Independent Peer Review Panel

IPRP Report No. 6, August 12, 2013

Site shear wave velocity at Diablo Canyon: summary of available data and comments on analysis by PG&E for Diablo Canyon Power Plant seismic hazard studies

Figure 3. Cross section of DCPD (Figure 5-3 in DCPD LTSP report, PG&E, 1991). The dashed curve is the original ground surface.

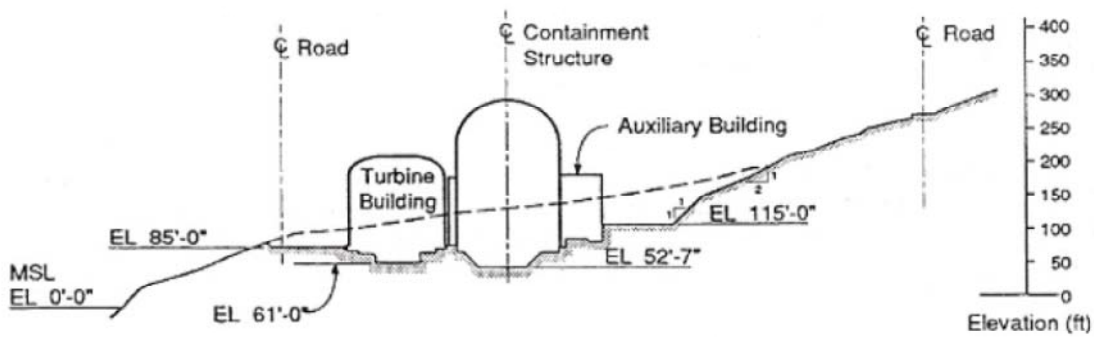
the power block. V_{S30} values were determined to be 1,212 m/s, 1,228 m/s, and 1,215 m/s for the mean 1978 profile near the power block and the two 1998 profiles at the ISFSI site. PG&E noted that the accuracy of the computed V_{S30} values for the ISFSI site is a few percent because the digitization of the ISFSI profiles has a limited accuracy of a few percent. The accuracy of the 1978 profile at the power block is not determined. PG&E also noted that the V_{S30} value of 1,200 m/s is at the power block embedment depth of 32.4 ft (or approximately 10 m) determined by the lower range of the original surface elevation of 85 ft (from mean sea level) minus the power block foundation elevation of 52.6 ft. We note that according to Figure 5-3 in the DCPD LTSP report (PG&E, 1991) (reproduced as Figure 3 in this memorandum), 52.6 ft represents the deepest part of the power block foundation. A considerable portion of the Turbine Building and Containment Structure is located less than 10 m from the surface and the Auxiliary Building is approximately at the level of the down-slope surface (i.e., elevation of 85 ft). A conservative measure would assume that these structures are located on the

ground surface. V_{S30} for the ground surface would be lower than at 10 m depth. PG&E indicated during meetings with IPRP that soil structure interaction (SSI) analysis is used to estimate ground motions at different elevations (or embedment levels), and the SSI analyses will incorporate a range of site-specific V_S profiles.

Figure 4. Shear wave velocity profiles from 1978 downhole velocity surveys (provided by PG&E).

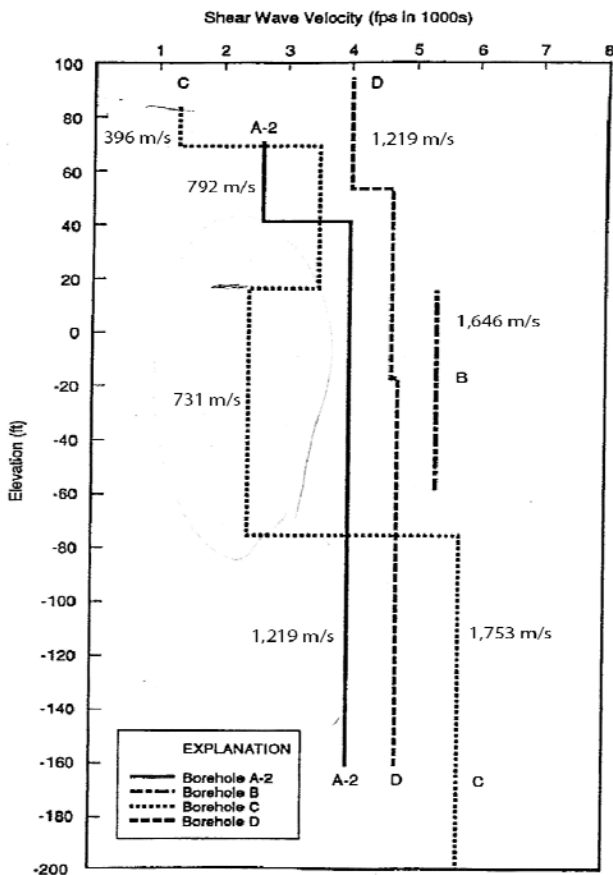
dated April 22, 2013), V_{S30} values from these four boreholes are 981 m/s, 1,646 m/s, 764 m/s and 1,347 m/s. The shear-wave velocity profile from borehole “B”, however, does not include any measurement from within 80 feet of the surface, so is not appropriate for use in calculating V_{S30} . Excluding borehole “B”, the mean is 1,031 m/s and standard deviation is 295 m/s, but even this mean is probably higher than the actual V_{S30} at the site. Borehole “C” includes no velocity measurements within 15 feet of the surface and Borehole “A-2” includes no velocity measurements within 30 feet of the surface. Considering that near-surface weathered rock is almost always lower in velocity than deeper unweathered rock, both the mean velocity and range of velocities in the upper 10 m are probably overestimates. In its response to the NRC RAI, PG&E developed a mean V_S profile and lower and upper bounds based on the four 1978 boreholes. Previous soil-structure interaction analyses using this range of uncertainty in V_S profiles found a significant effect of uncertainty in near surface V_S on soil-structure interaction. This effect may have been underestimated because of overestimates of V_S at shallow depths in the average profile by PG&E. Considering the three usable measured profiles, A-2, C, and D, the mean value at 10 m is approximately 800 m/s, considerably below PG&E’s mean of 1200 m/s. A mean value at 5 m is problematic because only profiles C and D measured velocities at that depth. If A-2 had the same velocity as C at a depth of 5 m, consistent with the relative weathering described in the borehole logs, the mean velocity at that depth would be about 650 m/s, also below PG&E’s mean value of 1000 m/s. The lower bound profile also appears to be overestimated at all depths because it approximates the measured velocities in borehole C. With only three profiles, it is unlikely that one of them represents the lowest velocity material underlying the plant. Some of the variability seen in the 1978 data may reflect poor quality of the V_S measurements made 35 years ago. Interpretations of that data, however, appear to include unconservative assumptions of velocity in boreholes where no velocity was recorded in the upper parts of the soil profile. Alternative interpretations suggest overall lower velocity of the rock underlying the plant and greater variability of velocity across the plant footprint. A complete consideration of site conditions across the plant footprint requires additional V_S measurements using modern technology to constrain the uncertainty and yield more reliable site V_S values.

Figure 5. Mean shear wave velocity profile and uncertainty from 1978 downhole velocity surveys and the simplified shear wave velocity profiles from ISFSI borings (plotted using data provided by PG&E).

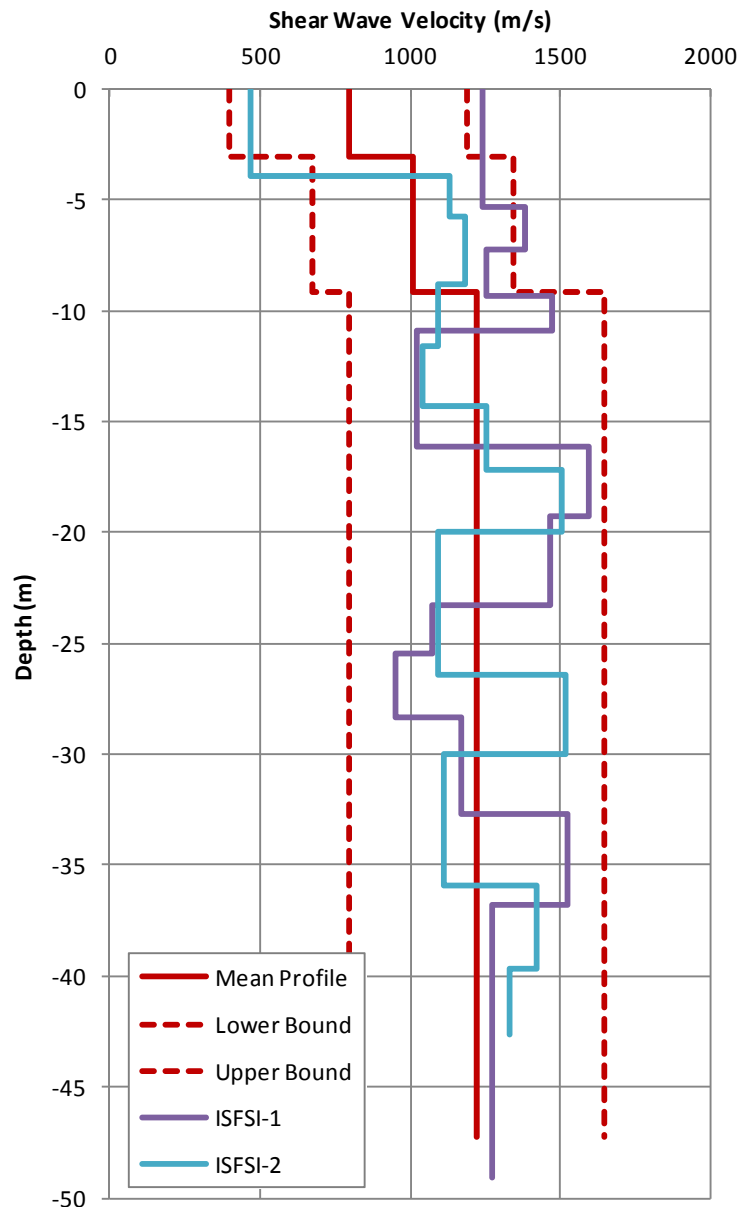
PG&E relied on the two newer profiles at the ISFSI site to justify the use of a mean V_{S30} value of 1,200 m/s because both the ISFSI and the power block are located on the same geologic unit (the Miocene Obispo Formation, which is composed of tuffaceous and diatomaceous sandstone and silty sandstone). Although the V_{S30} values derived from the two V_S profiles at the ISFSI site (1,228 m/s and 1,215 m/s) are consistent with a V_{S30} of 1,200 m/s, these two profiles do not give consistent V_S measurements at given depths. Considerable variability exists at some depth ranges (see Figure 5). V_{S30} values from these two boreholes would be 993 m/s and 1,214 m/s, respectively, if calculated

from the surface instead of from 10 m depth. While these two measurements support the high velocity measured in borehole D in 1978, they do not help constrain the lower bound or range of velocity at the plant site.

Since the Obispo Formation at the power plant is relatively well indurated sandstone, above average V_{S30} values are expected, but 1,200 m/s is higher than the expected range of values for this type of rock. Additional V_S measurements near the power block would give better assurance that variability in site V_{S30} value as well as near surface V_S profile is adequately captured and the values used in hazard analysis are well constrained, particularly because the rock at the DCPD site is both faulted and folded, leading to greater variability.

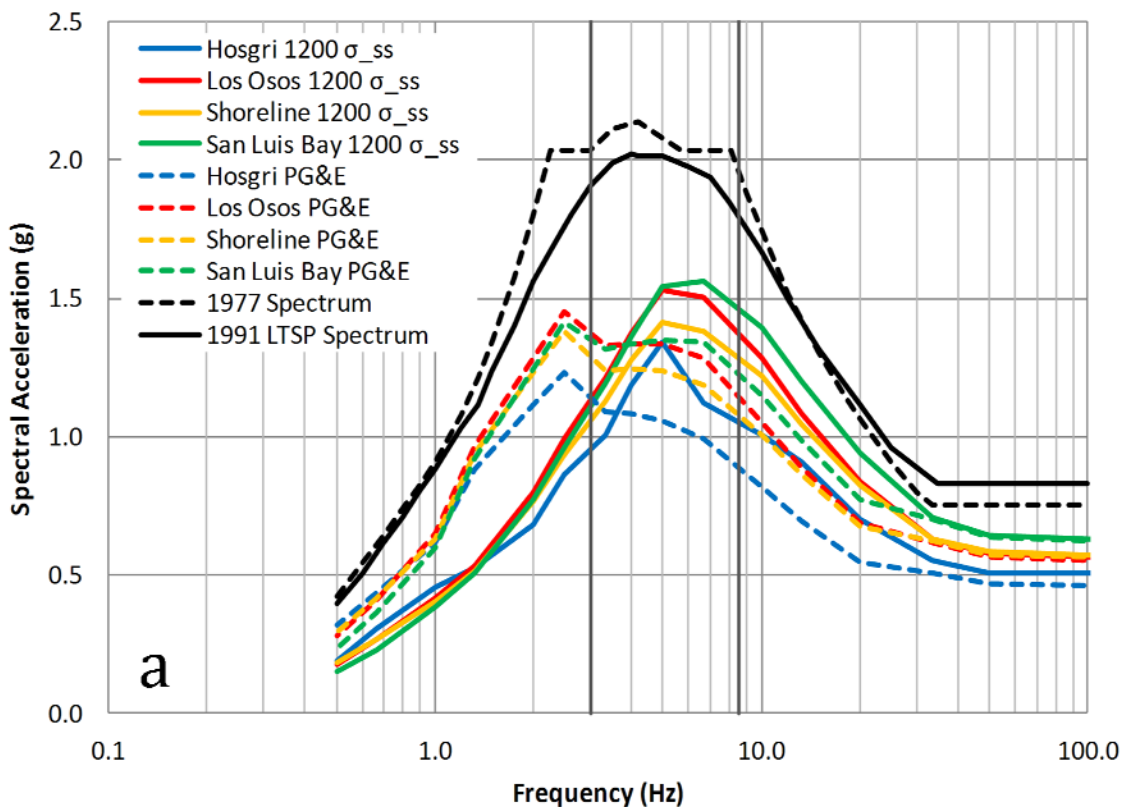
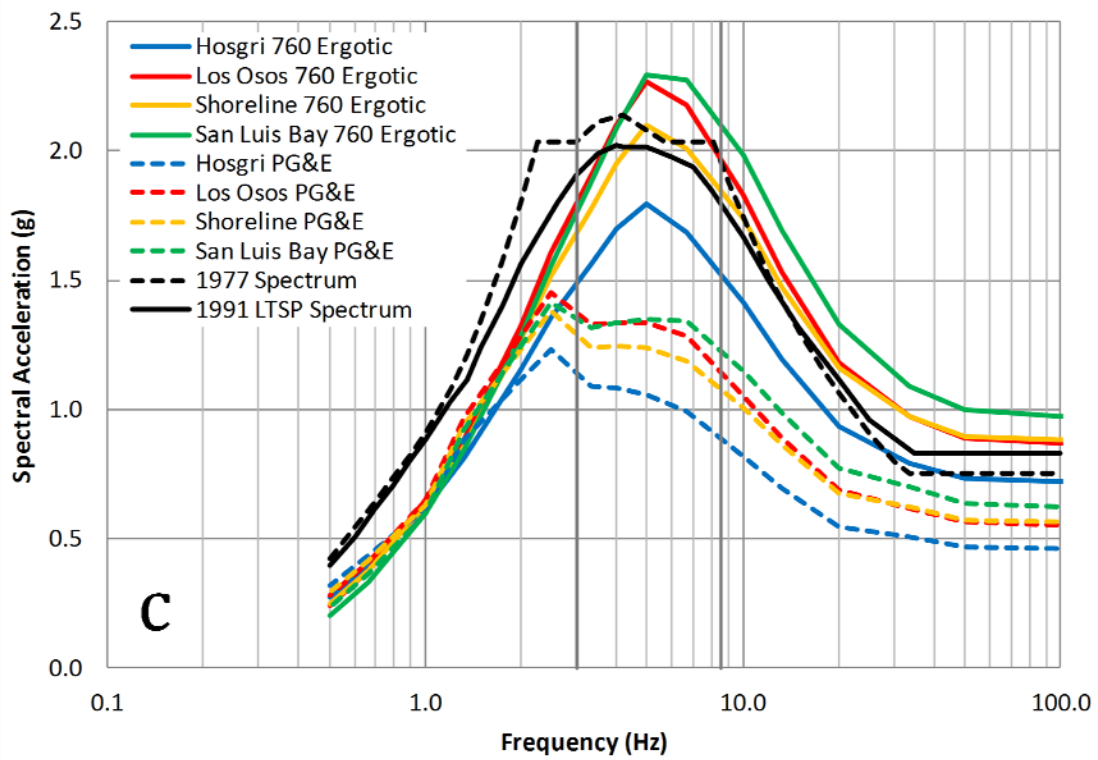
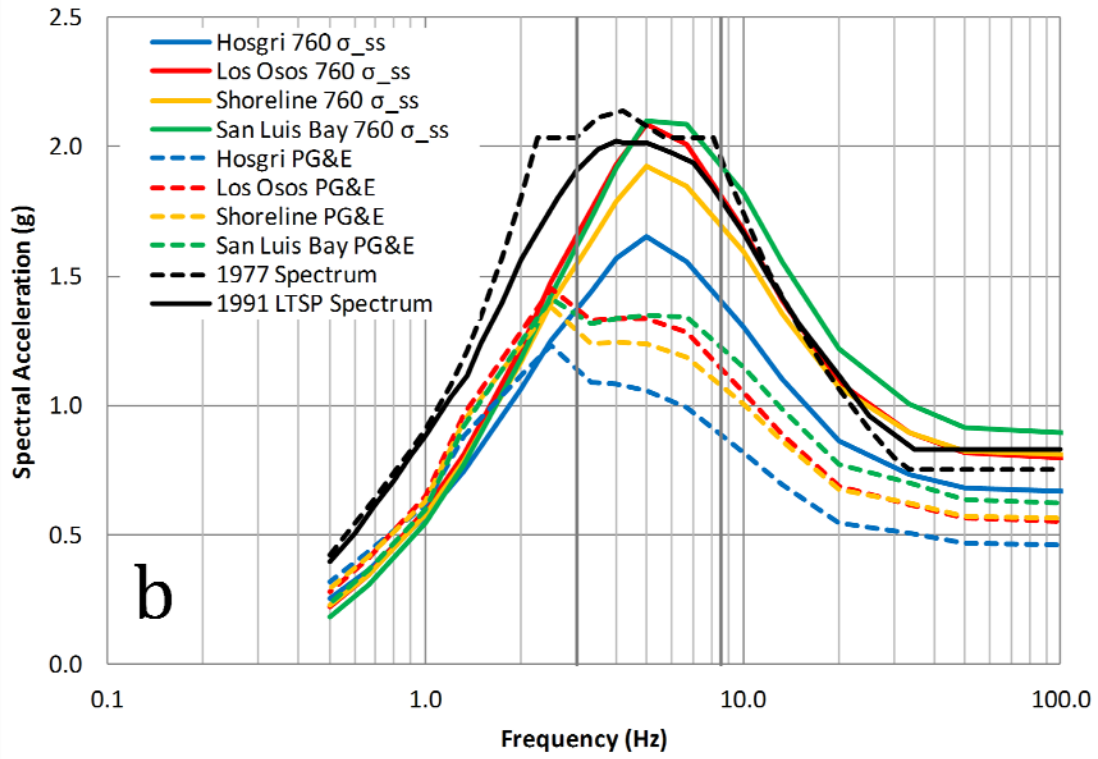
To demonstrate the significant effect of site amplification on estimated ground motion hazards at the DCPD site, we reproduced PG&E's deterministic ground motions (dashed curves in Figure 7) for the four main fault sources (the Hosgri fault, Los Osos fault, Shoreline fault, and San Luis Bay fault) and then did the same analysis for other site conditions. For dipping faults, the cases with the lowest estimated dip angles were analyzed. Table 1 lists input parameters for these deterministic calculations. These calculations used the same four NGAs used by PG&E: Boore and Atkinson (2008), Campbell and Bozorgnia (2008), Chiou and Youngs (2008), and Abrahamson and Silva (2008). Figure 7 compares PG&E 84th percentile deterministic ground motions (dashed curves) with those from three sensitivity cases (solid curves in Figures 7a, 7b, and 7c). The PG&E 1991 LTSP/SSER 34, the 1977 HE (Hosgri Earthquake) design spectrum, and the frequency range important to DCPD structures (marked by vertical dark grey lines) are plotted for reference. The PG&E calculation uses PG&E site-specific amplification factors derived from ground motion residuals, epistemic uncertainty in site-specific amplification factors, and single station sigma. The three sensitivity cases are: (i) a generic site with V_{S30} of 1,200 m/s (scaled from GMPE-predicted median for V_{S30} of 760 m/s using Silva scaling factors, single station sigma); (ii) a generic site with V_{S30} of 760 m/s (GMPE-predicted median without scaling) using single station sigma; and (iii) a generic site with V_{S30} of 760 m/s (GMPE-predicted median without scaling) using sigma from GMPEs (i.e., ergotic sigma). This figure shows significant effects of site condition

on deterministic ground motions. Compared to a generic rock site with V_{S30} of 1,200 m/s, the PG&E site-specific amplification factors shift peak spectral response toward lower frequency. They also lead to slightly lower peak spectral response for all four scenarios (Figure 7a). Compared to a generic site with V_{S30} of 760 m/s, the PG&E site specific ground motions are significantly lower, except for frequencies lower than approximately 2 Hz (Figures 7b and 7c). Comparison of these figures also shows that reducing the aleatory uncertainty in ground motion from GMPE sigma to single station sigma reduces predicted ground motion amplitudes across the spectrum (compare the set of solid curves in Figure 7b with that in Figure 7c). These two figures also show that if DCPD site had a V_{S30} value of 760 m/s rather than 1,200 m/s, and if the site behaves more like an average site in ground motion amplification, some deterministic spectra would exceed the 1991 LTSP spectrum.

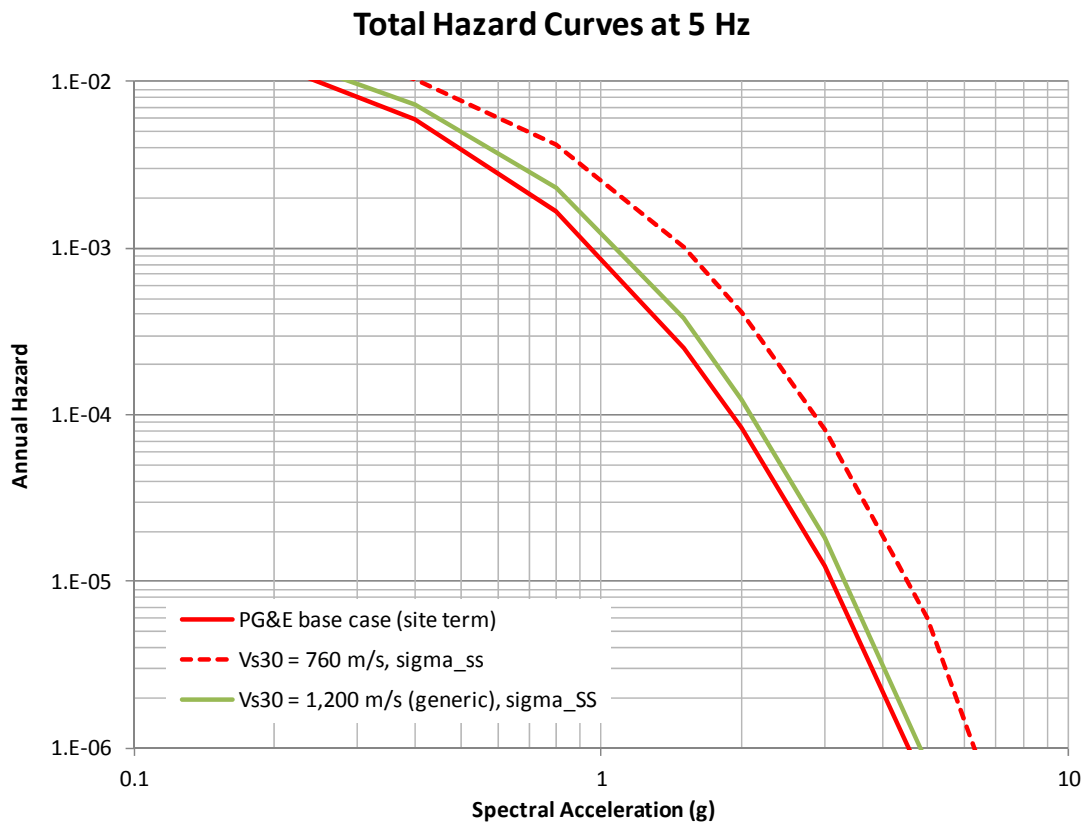
Figure 8 compares the total hazard curve that we reproduced using the PG&E base case input file provided by Norm Abrahamson without modification (solid red curve, using site-specific amplification term, a V_{S30} of 1200 m/s scaling, and single station sigma) with two sensitivity hazard curves: (i) for a generic site with V_{S30} of 760 m/s (dashed red curve, no scaling, single station sigma); and (ii) for a generic site with V_{S30} of 1,200 m/s (solid green curve, Silva scaling factor, single station sigma). This figure, once again, shows significant increase in ground motion hazards when PG&E site-specific amplification factors are not used and as V_{S30} value is decreased from 1200 m/s to 760 m/s.

Figure 10. Sensitivity shown as the ratio of sensitivity case hazard to PG&E base-case hazard for 5 Hz spectral acceleration at 2 g.

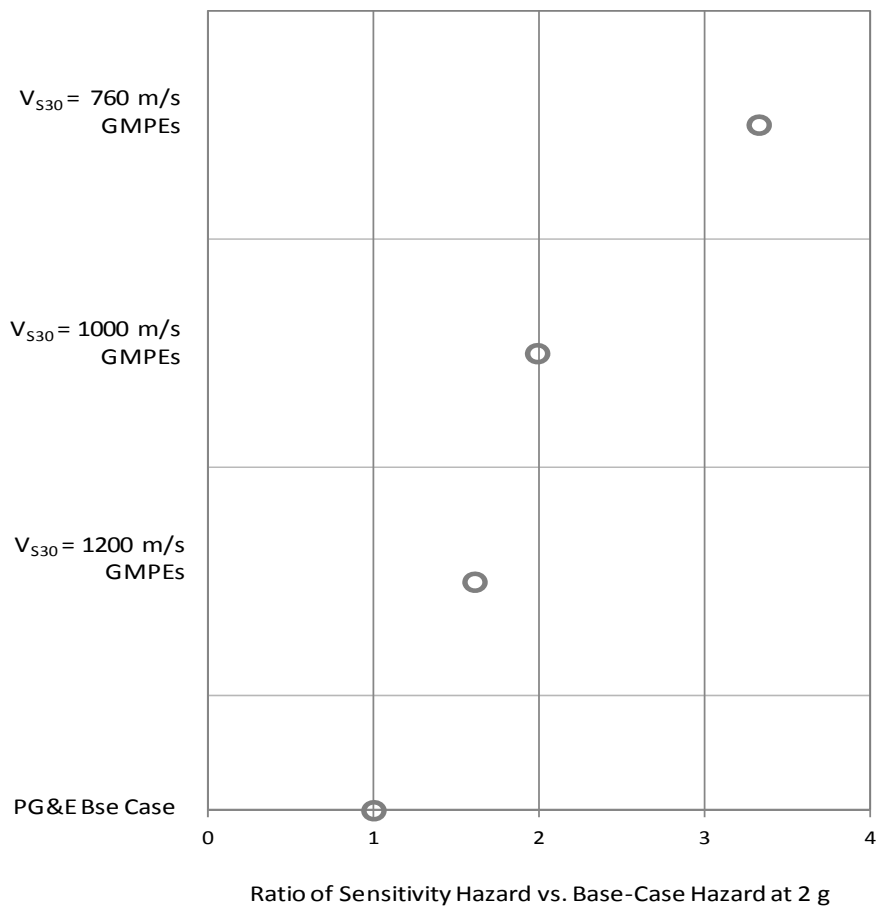
We constructed a similar “tornado plot” (Figure 10) to put the effect of site condition in the same perspective as source parameters studied by PG&E (2011b). In Figure 10, the horizontal axis is the ratio of 5 Hz sensitivity case hazard to base-case hazard at spectral acceleration of 2g. PG&E base case used site-specific amplification term, its uncertainty, and single station sigma. All other cases used unscaled GMPE medians with V_{S30} values indicated in the figure. This figure shows that changing site condition from PG&E characterized DCPD site to a generic site with V_{S30} of 760 m/s increases the hazard by more than a factor of 3 (compare hazards for PG&E base case and the 760 m/s case). Changing site condition from PG&E base case to a generic site with V_{S30} of 1000 m/s increases hazard by a factor of 2.

Figure 11. Comparison of mean hazard curve for 3-8.5 Hz for V_{S30} of 760 m/s with PG&E base case and the 1988 LTSP curves.

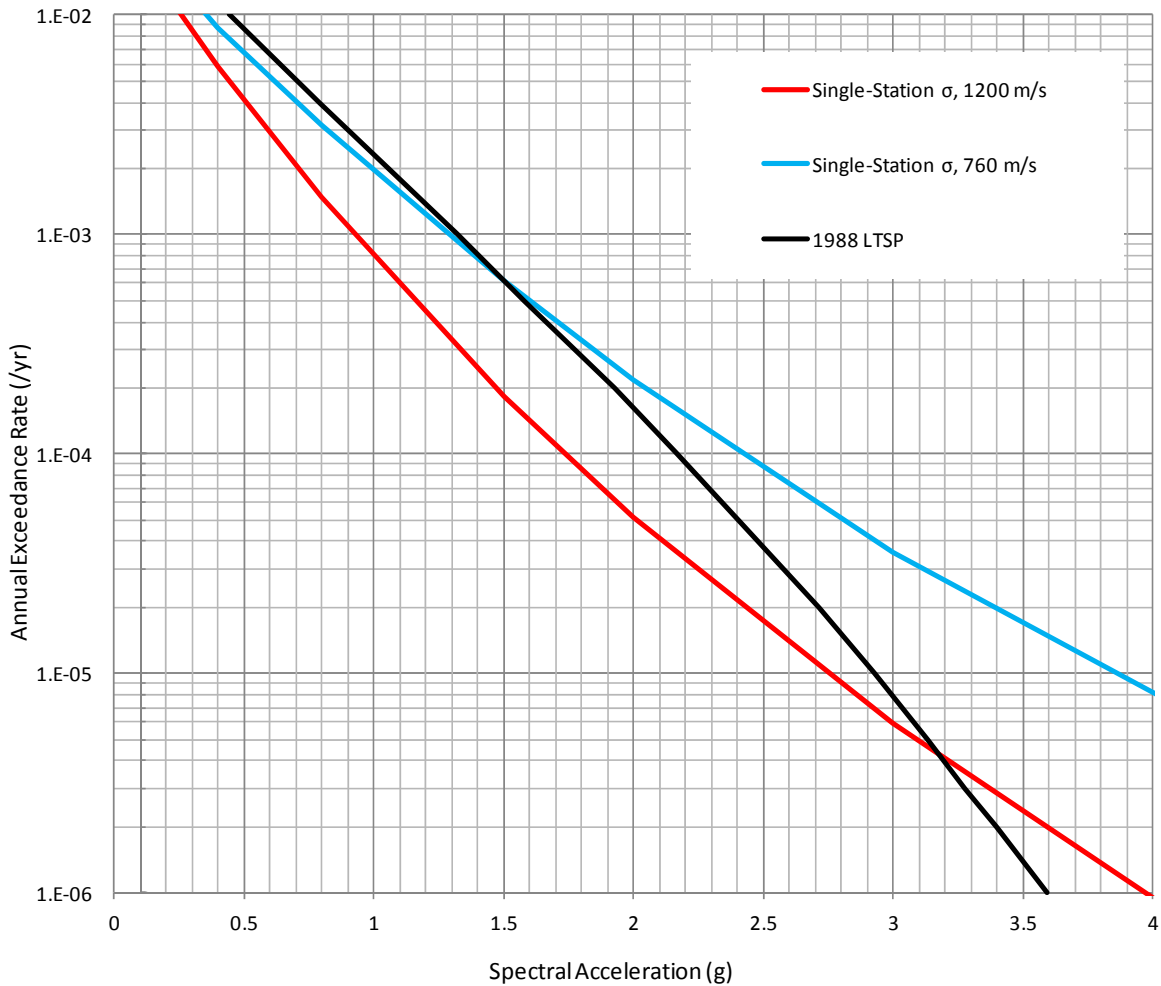
The fragility used for DCPD is based on the spectral acceleration averaged over the frequency band of 3 – 8.5 Hz. Figure 11 shows the significant effect of site condition on this ground motion parameter. Also plotted on this figure is the 1988 LTSP hazard curve for comparison. This figure shows that changing site condition from PG&E characterized DCPD site to a generic site with V_{S30} of 760 m/s brings the average ground motion over the frequency band of 3-8.5 Hz above the 1988 LTSP curve (PG&E, 1988) for acceleration greater than about 1.5 g (i.e., hazard level of approximately 7×10^{-4} or return period of approximately 1,428 years).
